DR98-120 PROPOSED WATERFRONT HOTEL

REQUEST: Design Review of a proposed waterfront hotel

**NOTICE OF DECISIONS AND FINDINGS OF FACT FOR
PROPERTY LOCATED AT Capitol Mall and Front Street
SACRAMENTO, CALIFORNIA IN
THE CENTRAL CITY CENTRAL BUSINESS DISTRICT
DESIGN REVIEW AREA (DR98-120)**

NORTH ELEVATION

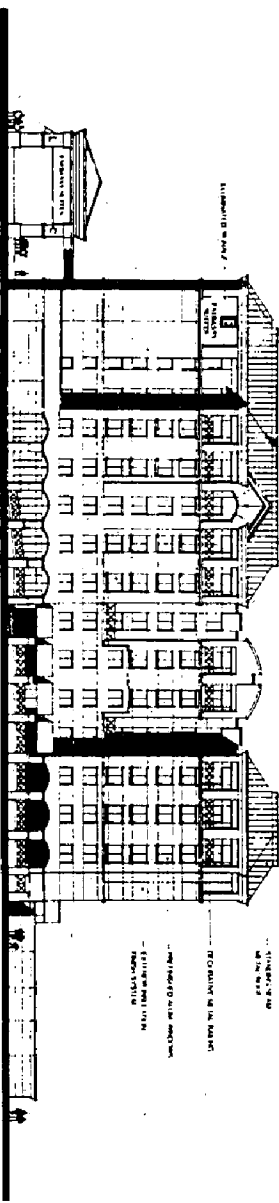
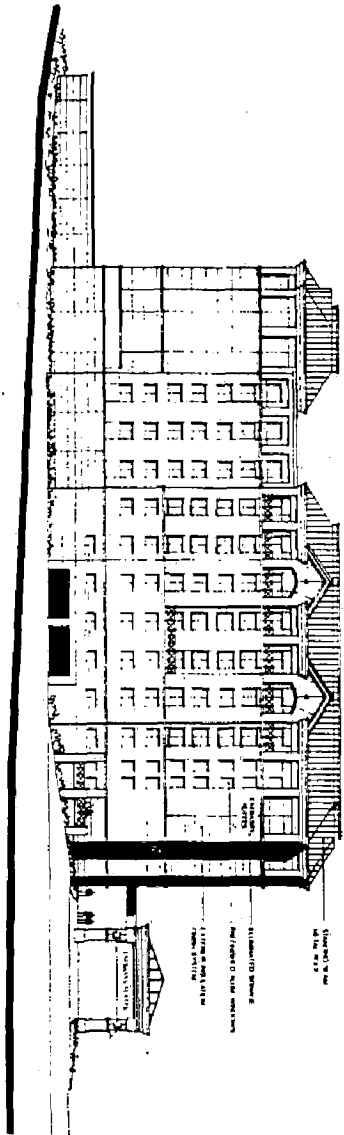
1. Look at blank walls, add detail or windows, especially those facing the Crocker Art Museum.
2. Add roof line to the se corner of the building.
3. Add more color to the bldg, explore using different colors.
4. Look at adding railing to all the windows.

1. Need more interesting features on the east side.
2. Building looks to sterile, needs more detail, railings, etc.
3. Needs more design enhancements.
4. This site is important, need to have a good design.

The Planning Commission approved the entitlements for the project and also mentioned the need to explore other materials at the base, strive for a unique look, provide subtle yet rich colors, possibly add a trellis to the outdoor eating area, articulate the flat roof at the se corner visible from the Crocker, and try not to use beige and brown.

1. Provide a stronger sense of entry.
2. Do not add more balconies, they would appear "pasted on".
3. Add windows on some of the blank walls, but allow the wall facing east to remain as proposed, simply adding greater definition at the top, with a cornice treatment.
4. The roof should be a high quality metal roof, with a "batten" design.
5. Lower the color line as proposed by the architect.
6. Provide additional detailing at the windows, better define the sill piece.
7. Acknowledge the budgetary issues related to achieving the best design.
8. Precast panels at the portecochere and restaurant outdoor area should have a "honed" finish, not highly polished, preferably.

12. The massing of the project shall be broken up with the use of both vertical and horizontal planar changes and building step backs as proposed in the elevations reviewed by the Board. Decorative metal balconies shall be used at the upper windows to add further depth to the facade. The roof line shall be broken up by utilizing a combination of roofed areas and parapet walls as indicated in the elevations reviewed by the Board.

LANDSCAPE PLAN

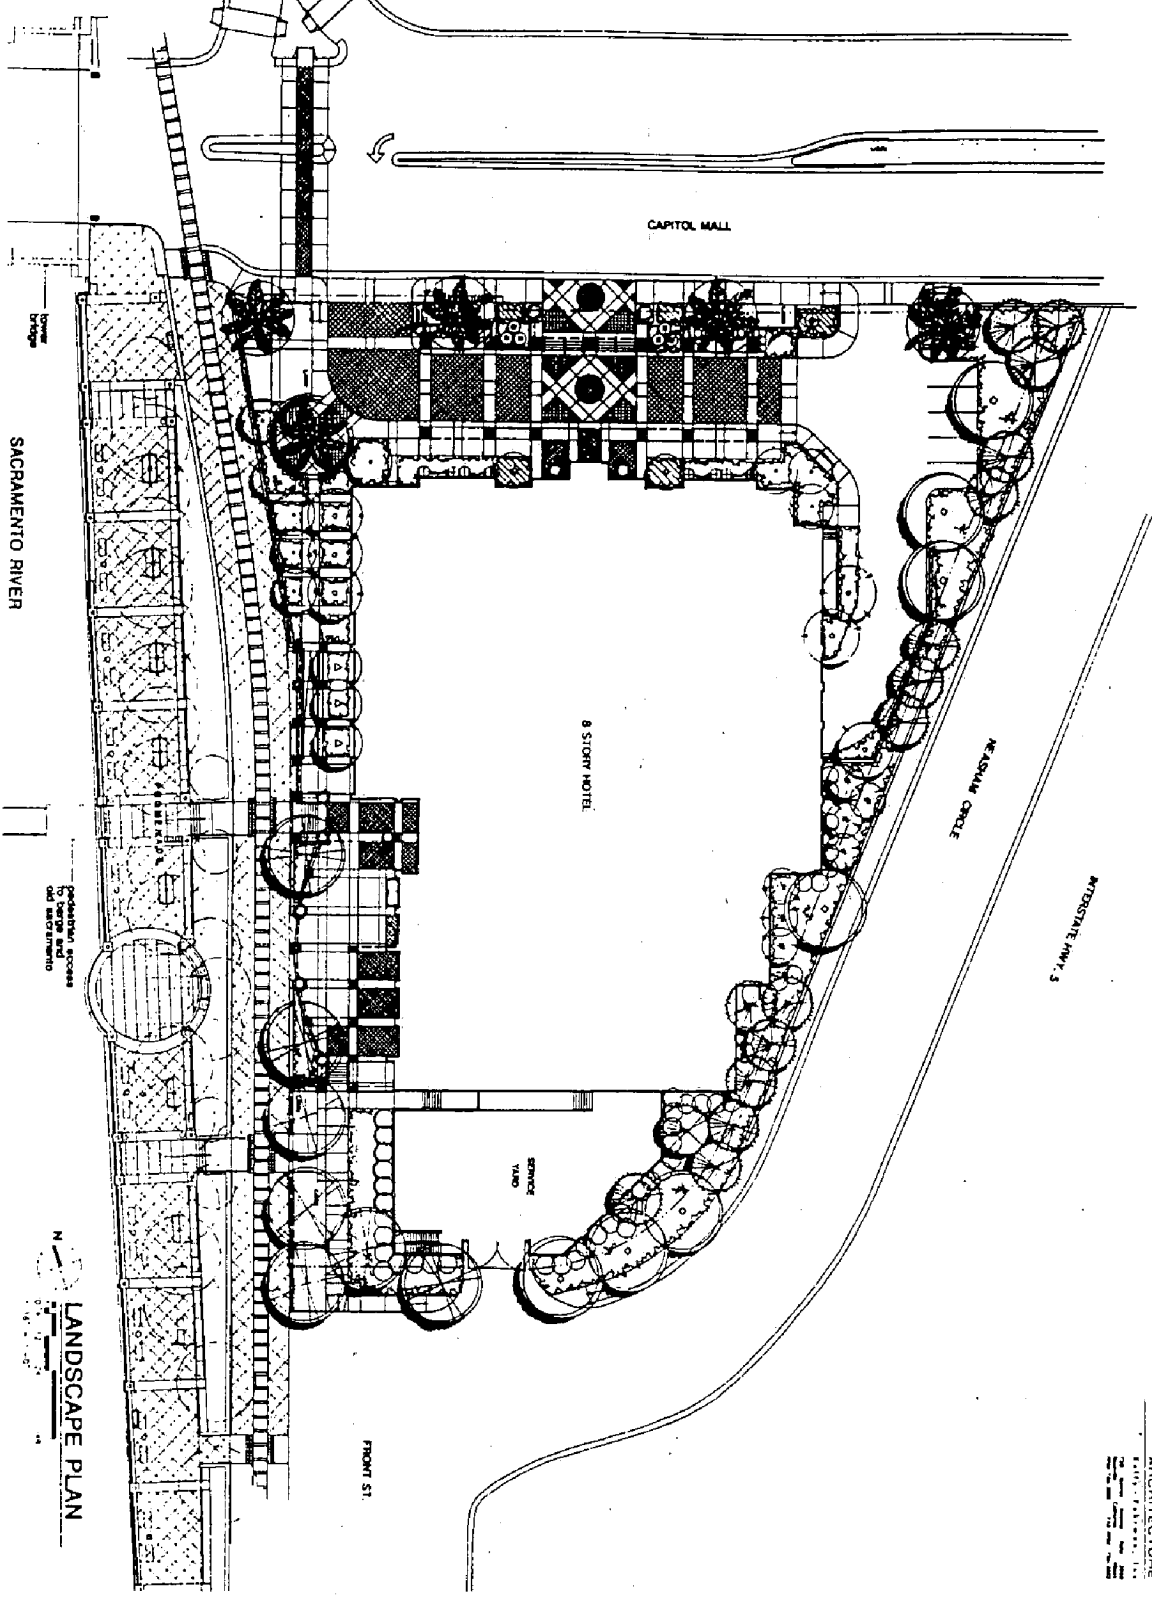
4. Final landscaping plans have not been developed, but the Urban Design Plan encourages street trees, as well as landscaping on site. Street trees should be planted in decorative metal grates along Capitol Mall. Landscaping along the riverfront property line should complement the landscaping scheme of the recently completed Promenade. The proposed landscaping is only representational, but includes the use of palms as street trees. The applicant should provide the Board with a better developed landscaping plan indicating the types of trees proposed for the site.

2. Auto access to the site shall be off of Capitol Mall as proposed.
 3. Final landscaping plans shall be reviewed and approved by the Board's landscape architect and Design Review staff. All new landscaping shall be the most mature planting possible. The minimum tree size shall be 24 inch box, with more mature shrubbery also planted.
